ADDENDUM NO. 2

November 2, 2021

CROWN POINT HIGH SCHOOL ADDITIONS AND RENOVATIONS **Crown Point, IN 46307**

This Addendum consists of Pages ADD 2-1 through ADD 2-2 and attached Addendum No. 2 from Gibraltar Design dated October 29, 2021 and consisting of 12 pages, Specification Section 04 01 00 - Masonry Cleaning, Specification Section 12 25 00 - Roller Shades, and 134 drawings.

© GIBALTAR DESIGN SHEET
M P-112

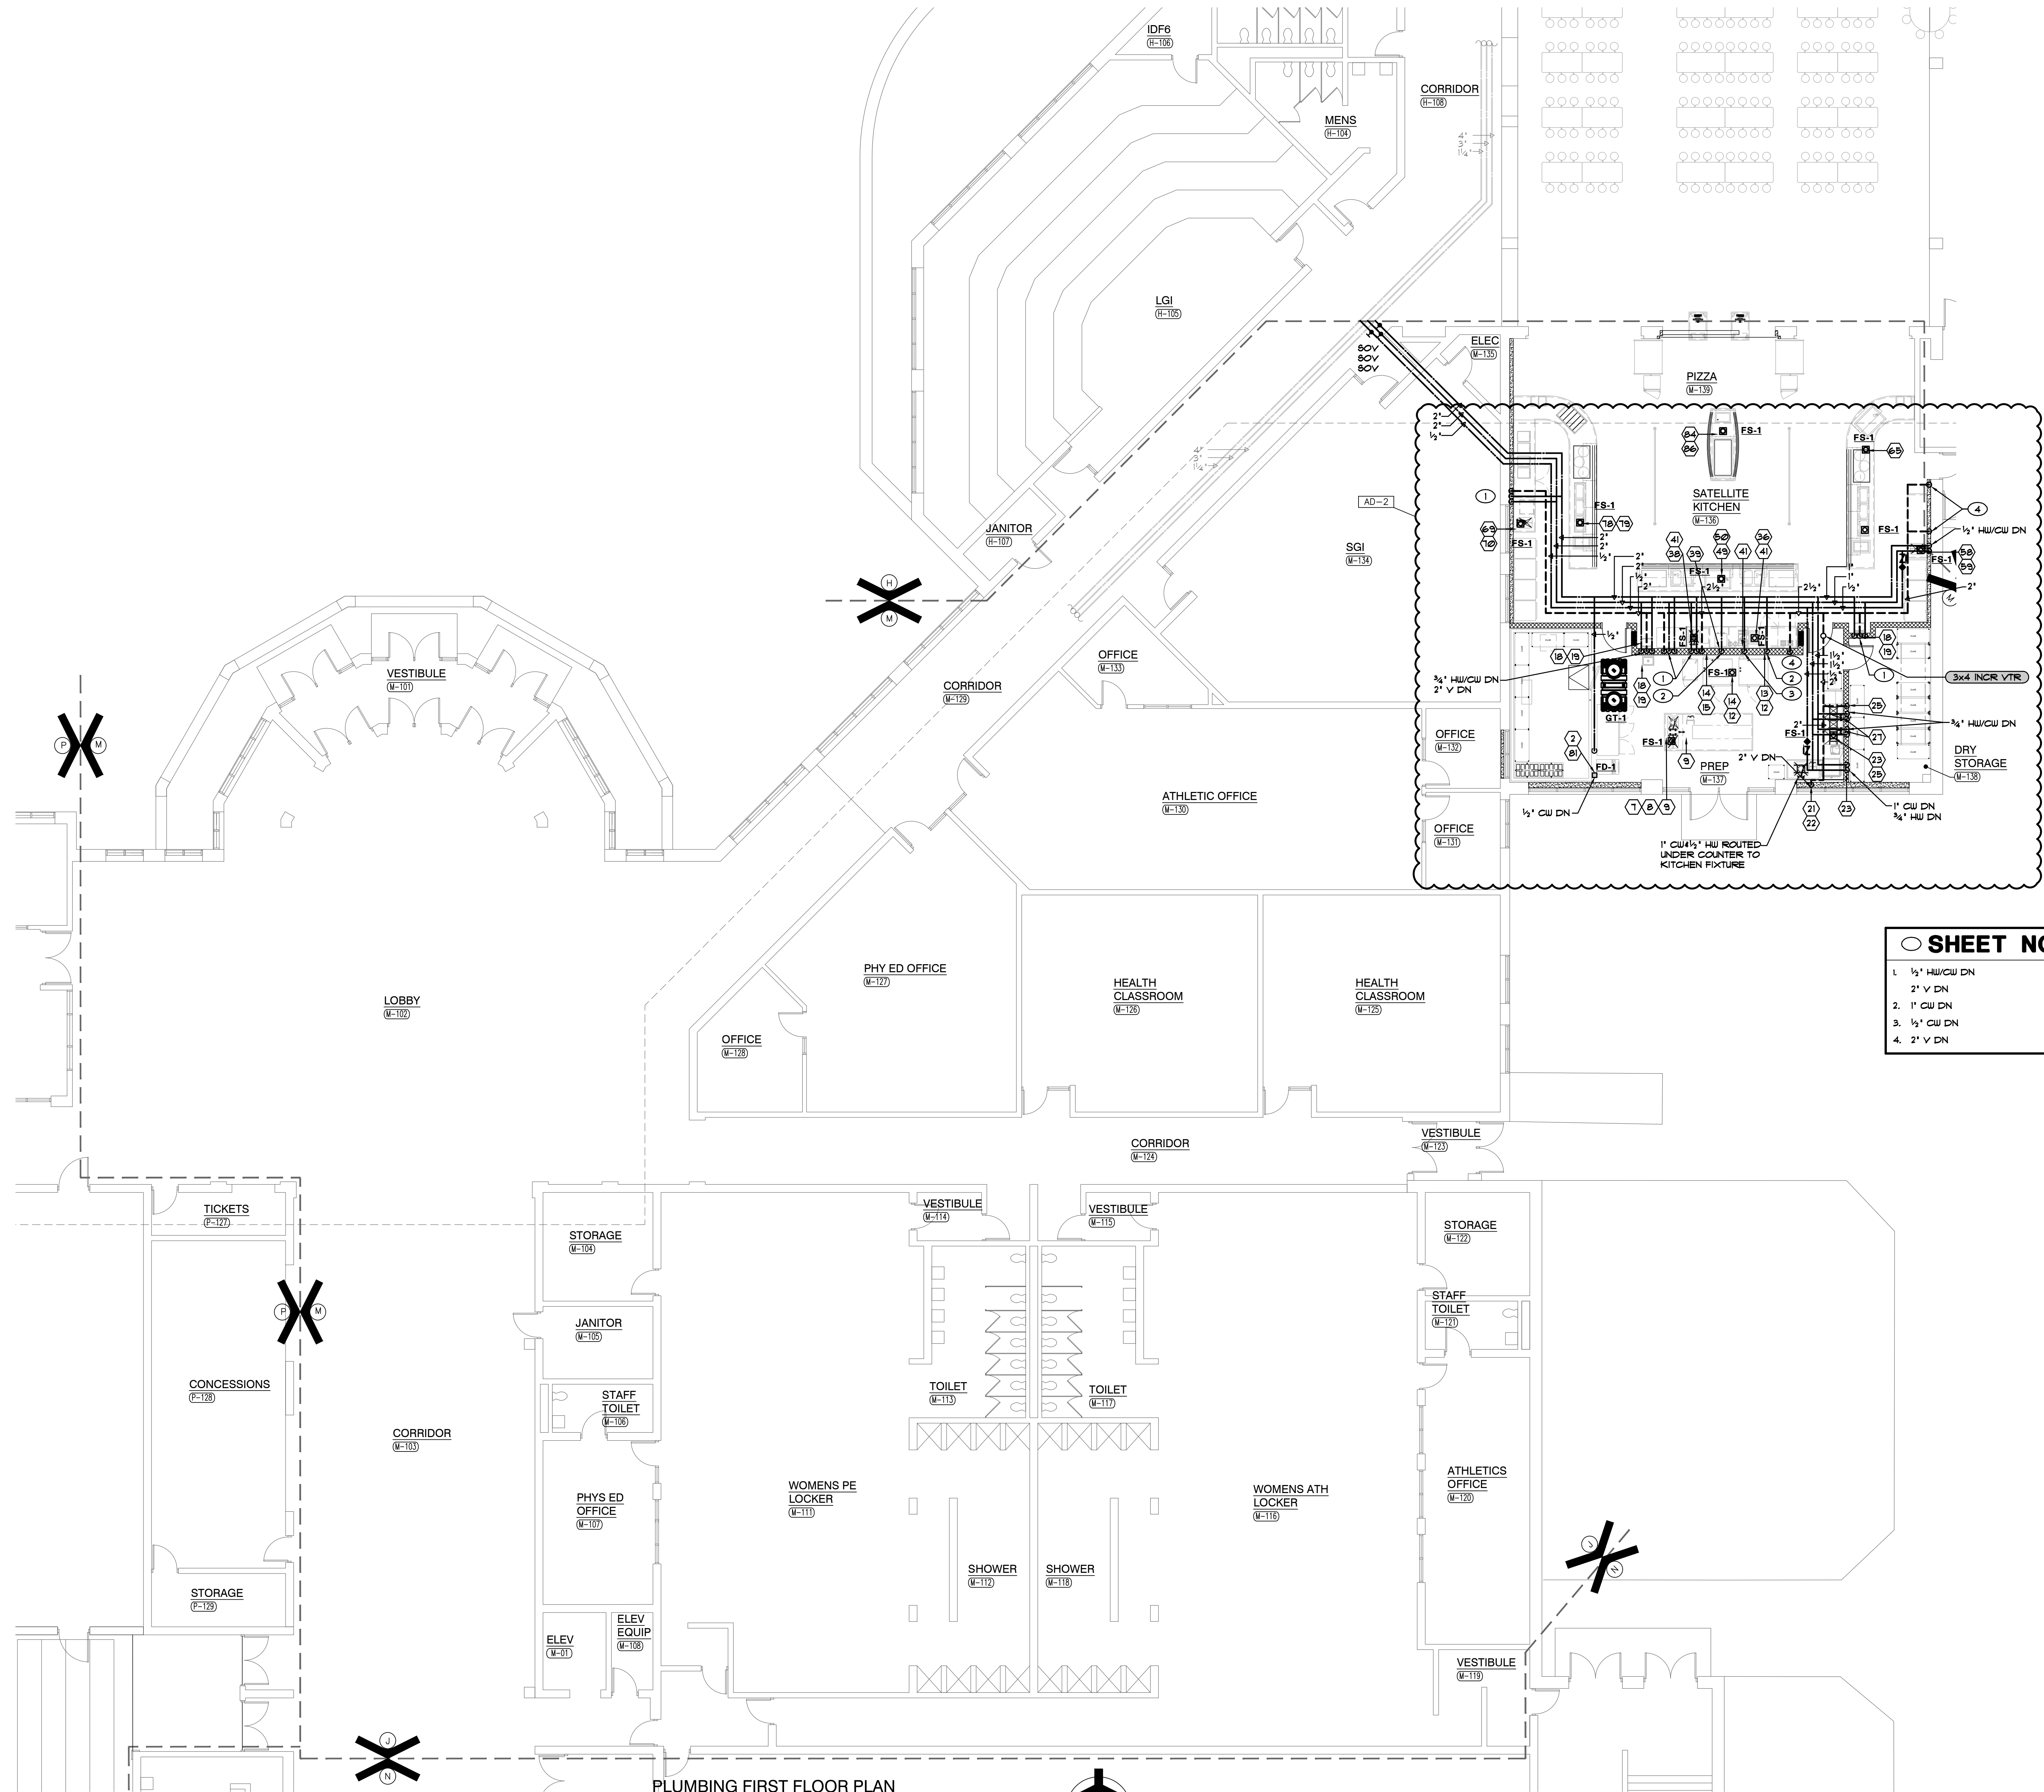
64. Sheet P-112

© GIBRALTAR DESIGN SHEET
M P-212

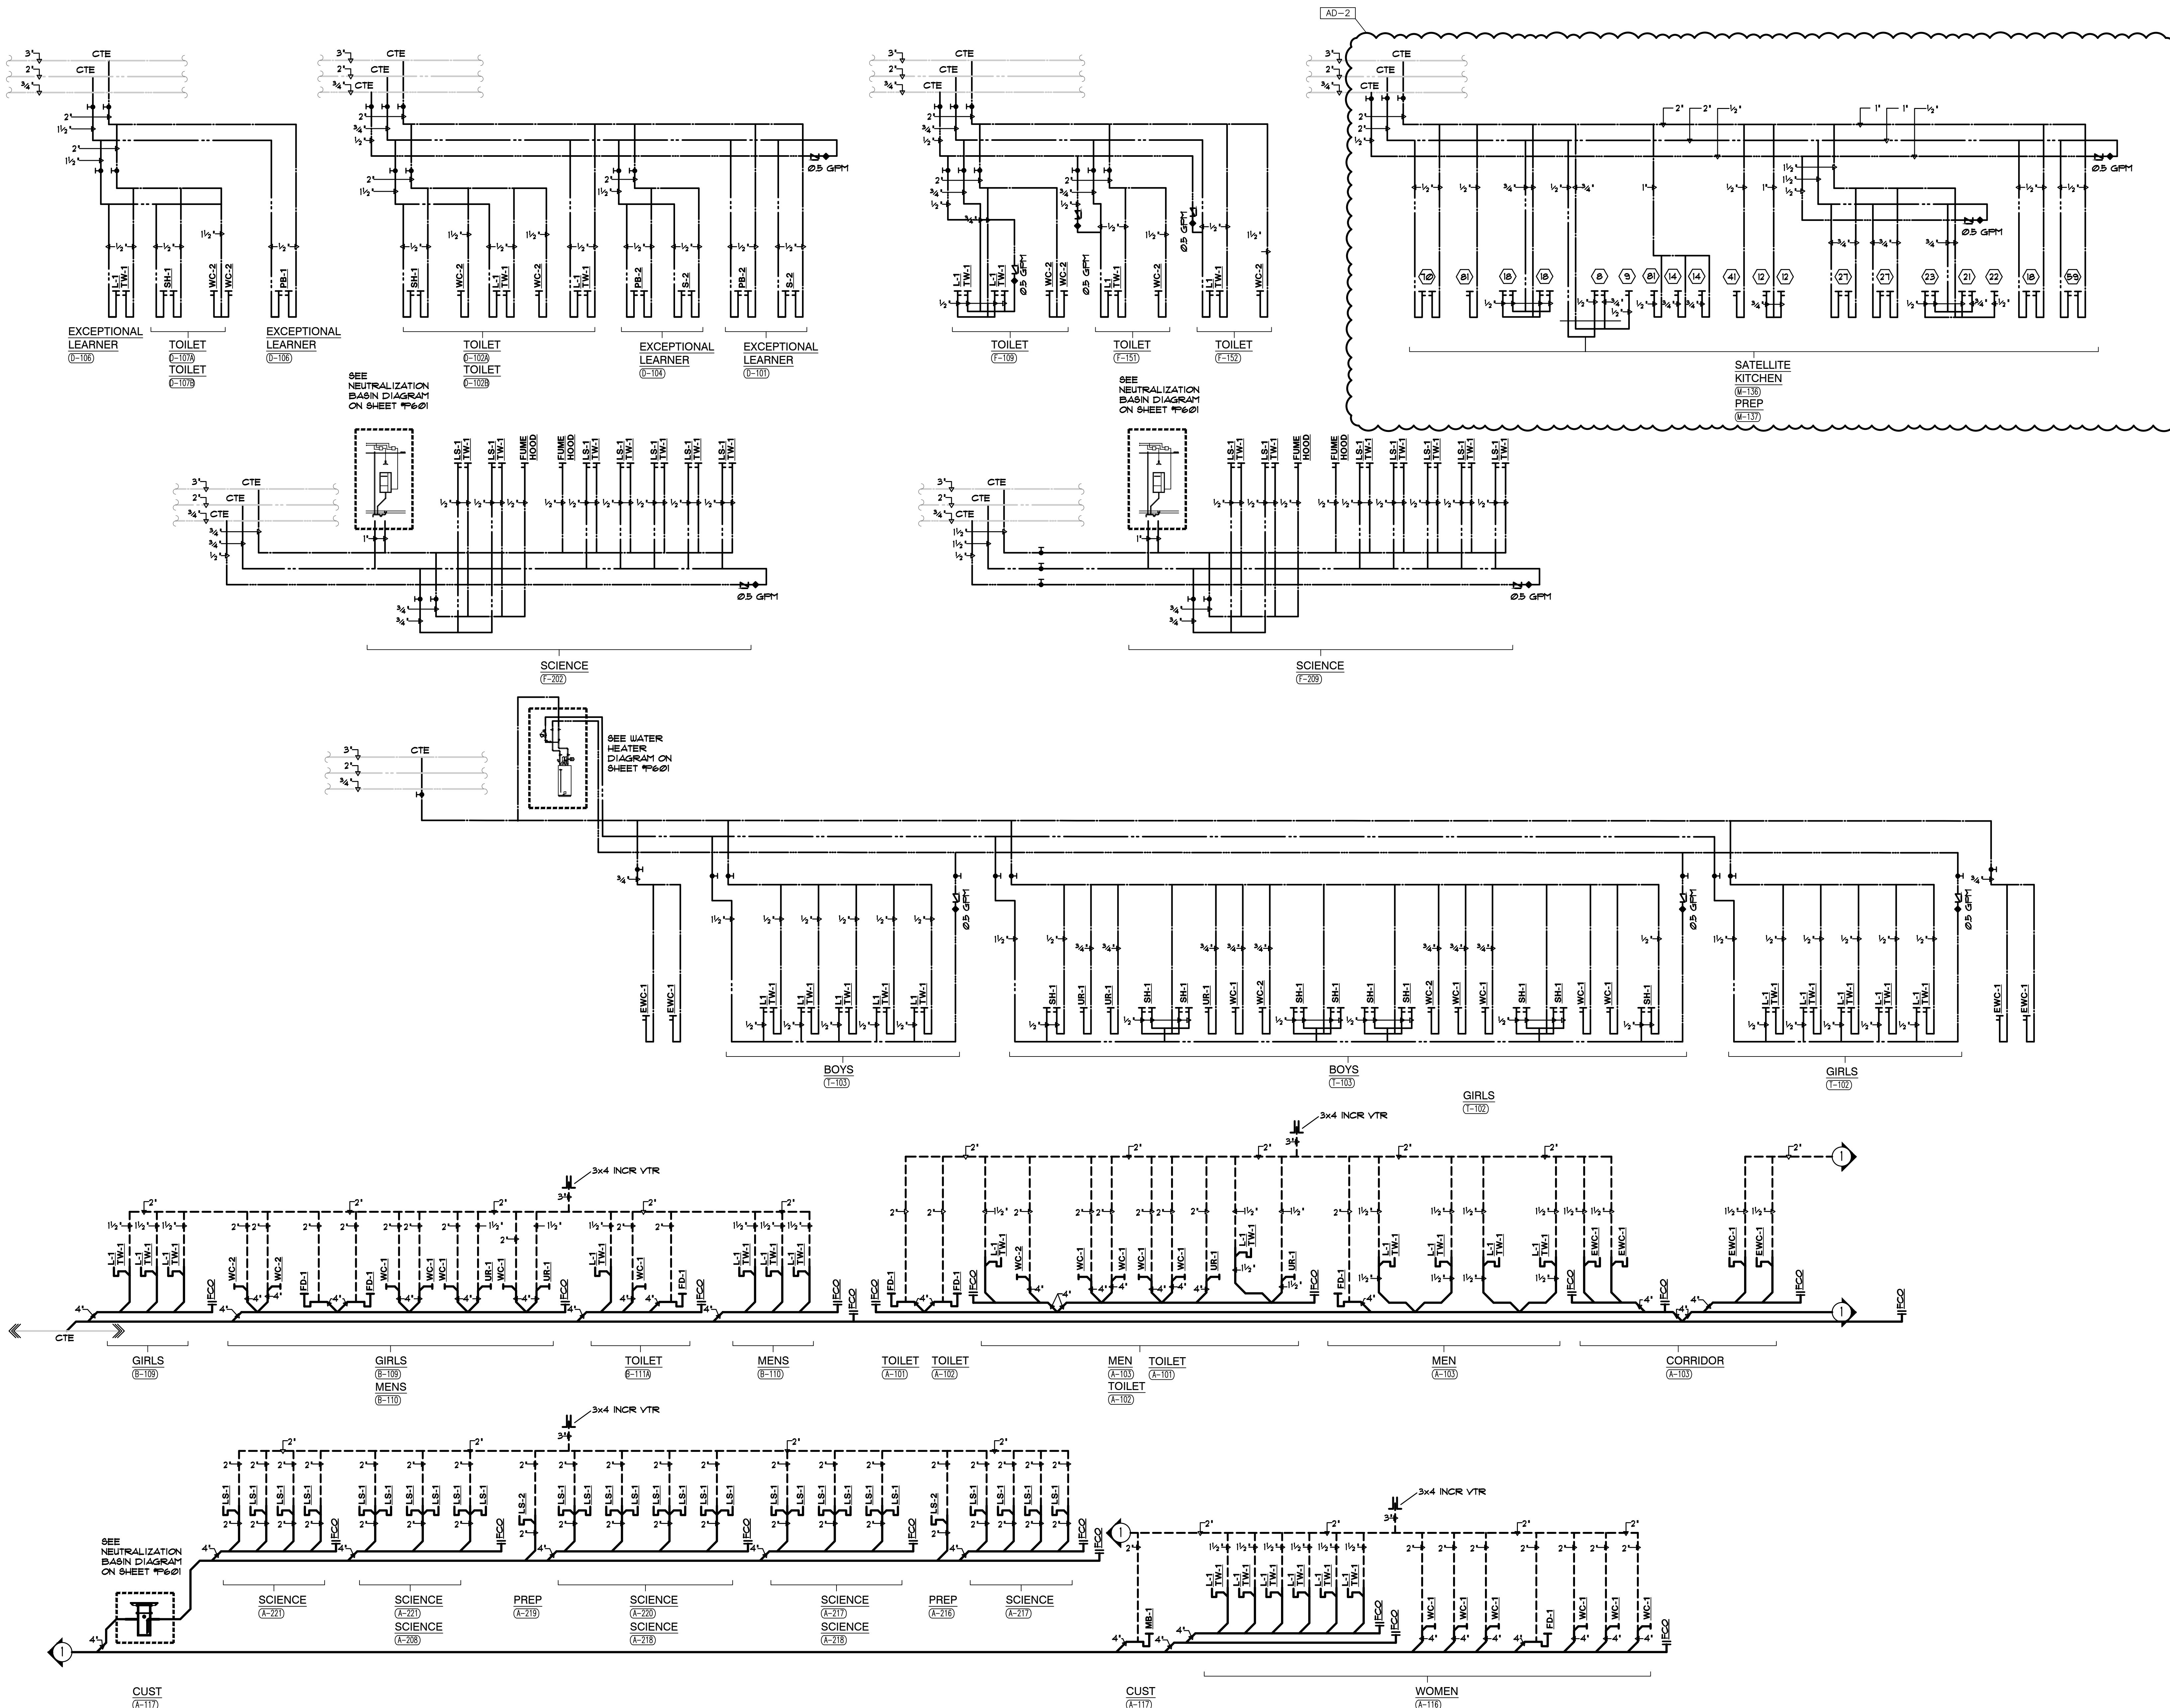
66. Sheet P-212

© GIBRALTAR DESIGN SHEET
K EL110

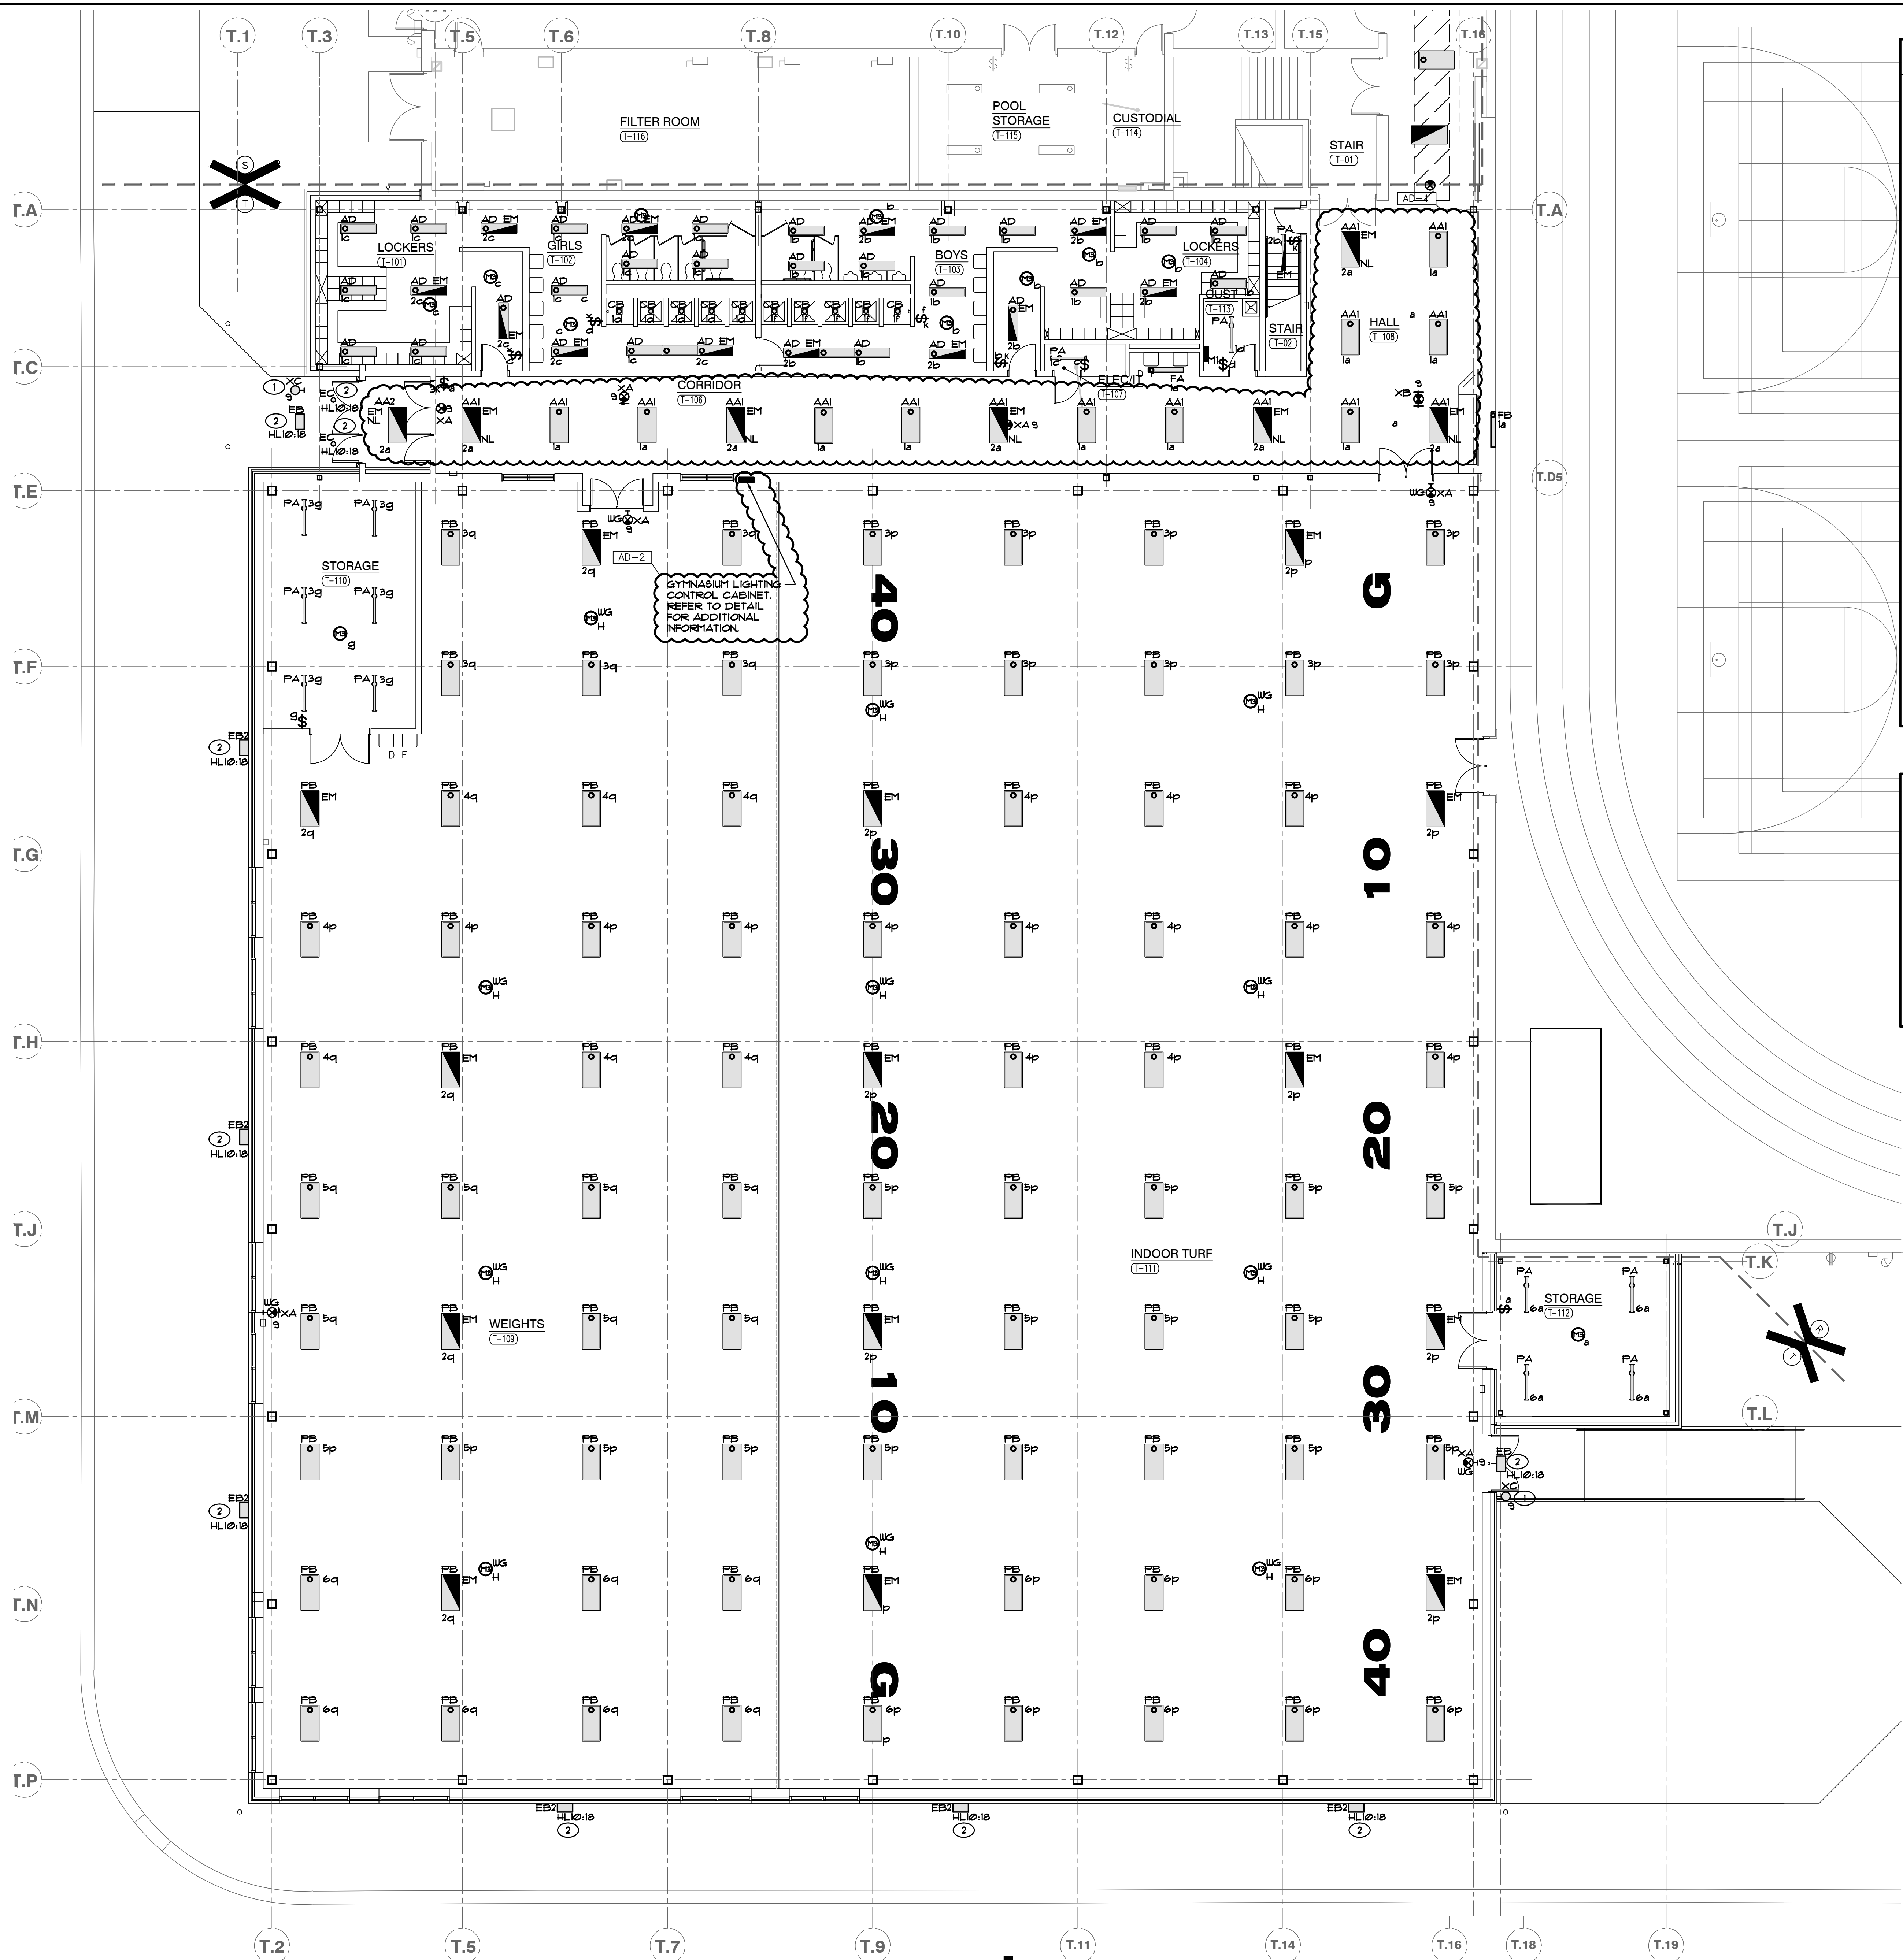
77. Sheet EL110
